HISTORIC AND DESIGN REVIEW COMMISSION

June 06, 2018

HDRC CASE NO: 2018-255
ADDRESS: 257 BUSTILLOS DR
LEGAL DESCRIPTION: NCB 7674 BLK C LOT PT OF TR 1 OR J, EXC SE 7.06 FT
ZONING: R-5, H
CITY COUNCIL DIST.: 3
DISTRICT: Mission Historic District
APPLICANT: Ronald Anguiano
OWNER: Rosie Anguiano
TYPE OF WORK: Installation of carport
APPLICATION RECEIVED: May 11, 2018
60-DAY REVIEW: July 10, 2018
REQUEST:

The applicant is requesting a Certificate of Appropriateness for approval to install a metal carport featuring 360 square feet.

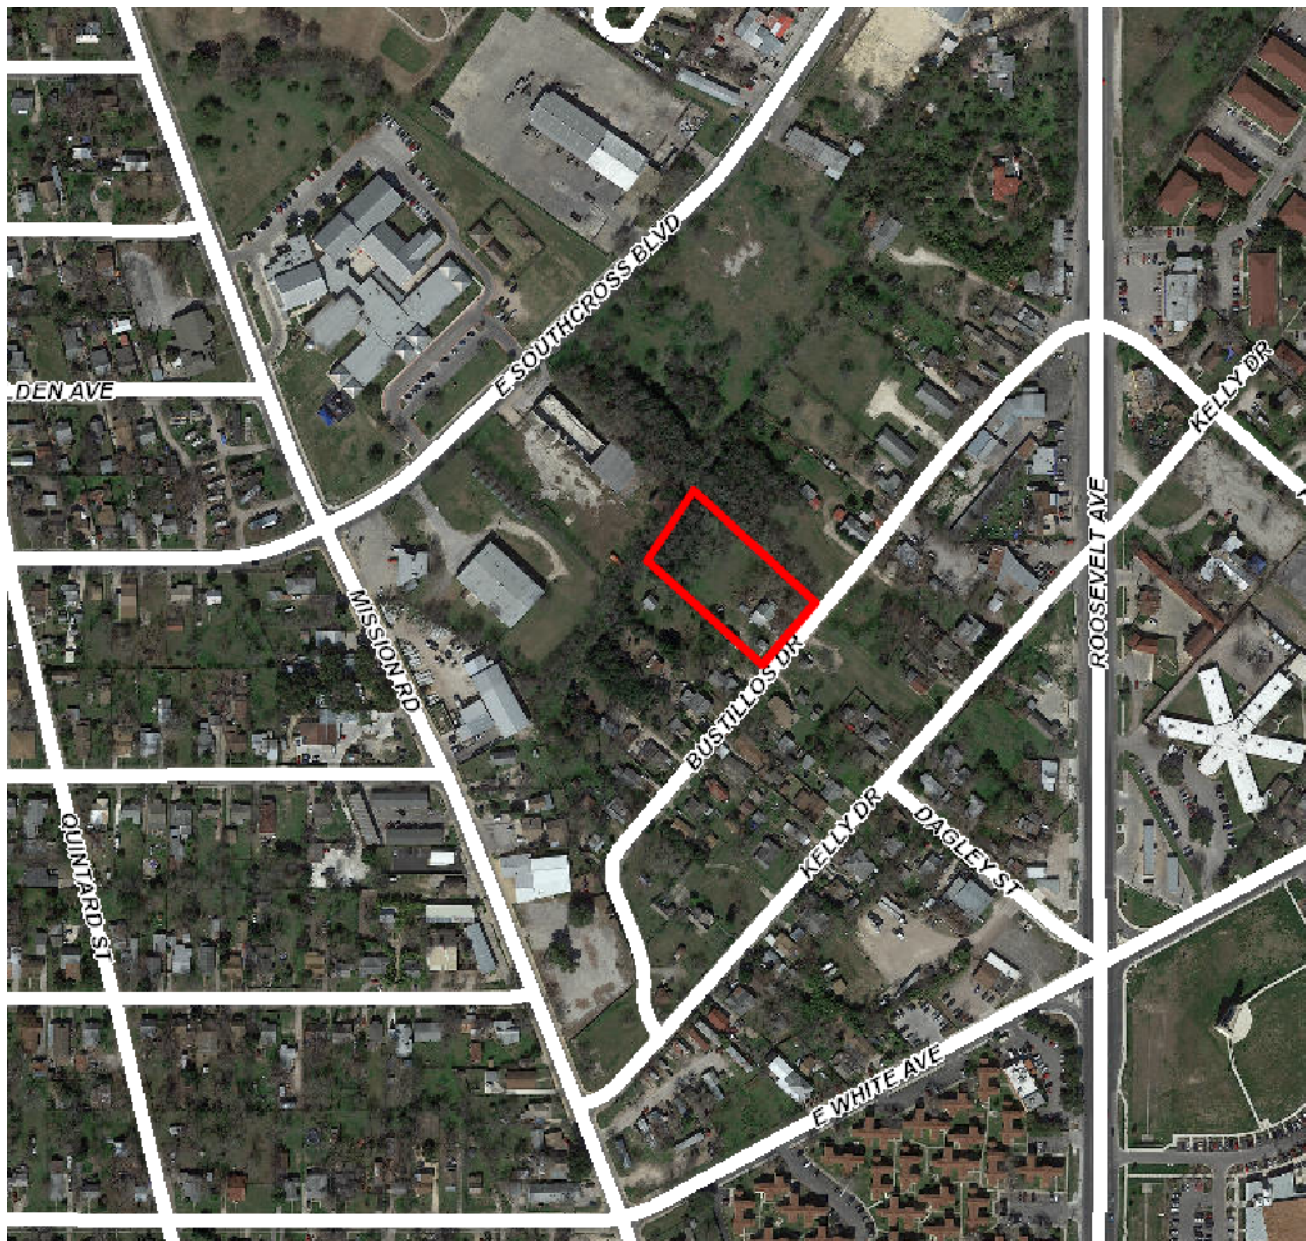
- a. The structure at 257 Bustillo was constructed circa 1960 in the minimal traditional style with Colonial Revival influence. The one-and-a-half story structure features shingle gabled roof with two dormers and a flanking non-confirming side addition.
- b. CARPORT – The applicant has proposed to install a 360 sq ft and 11 ft tall carport to the side of the existing

concrete driveway. The carport is prefabricated featuring metal framing and a corrugated metal roof. The applicant has not requested the installation of a foundation or additional driveway width at this time. While the carport is not consistent with the Guidelines, staff finds the proposal appropriate considering it is easily removable, no additional concrete is required, and it is located away from the primary structure.

Staff recommends approval based on finding b with the stipulation that no additional concrete is added to the driveway or property.

- Property line
- 360 SQ Ft Detached Carport
- Softbacks

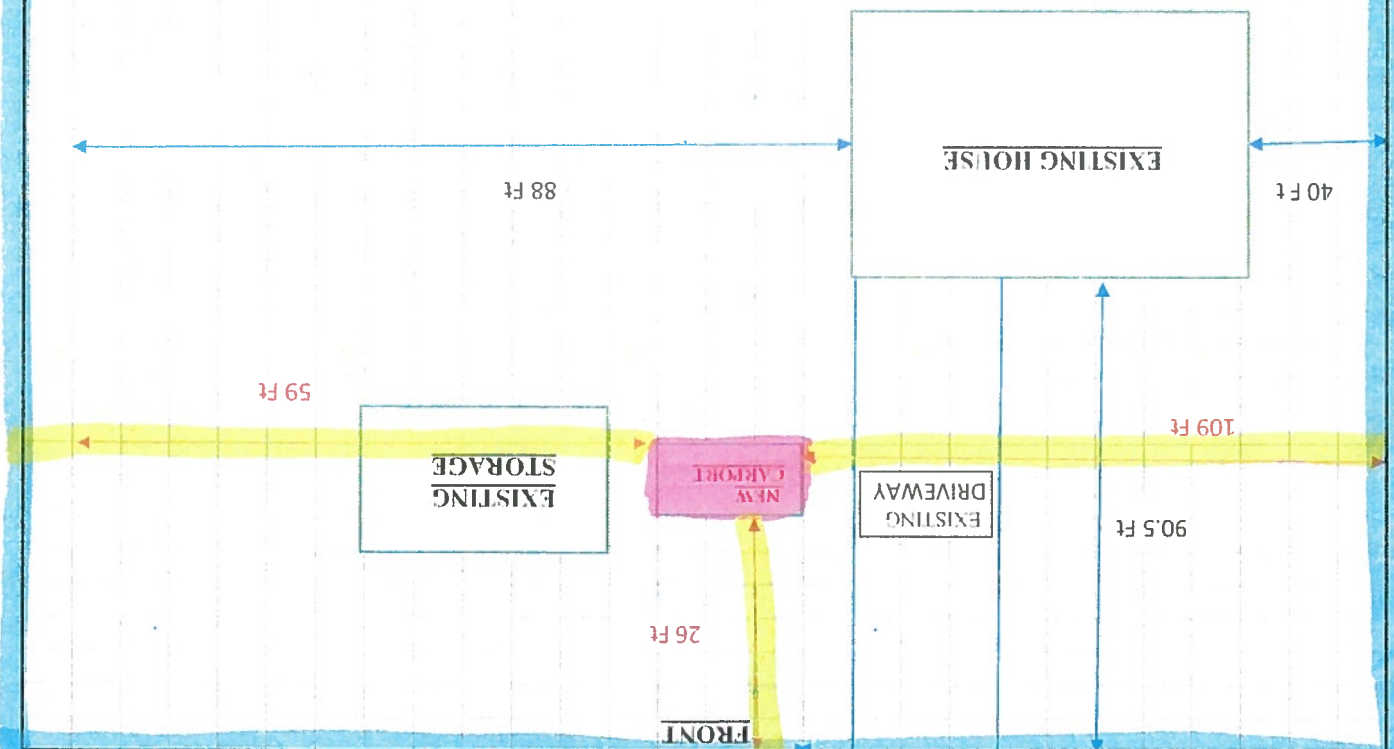
NOTICE:
Engineer's Letter Required to Clear
Foundation/Frame Inspection.
Customer Initial: RD
Rep. Initial: EG
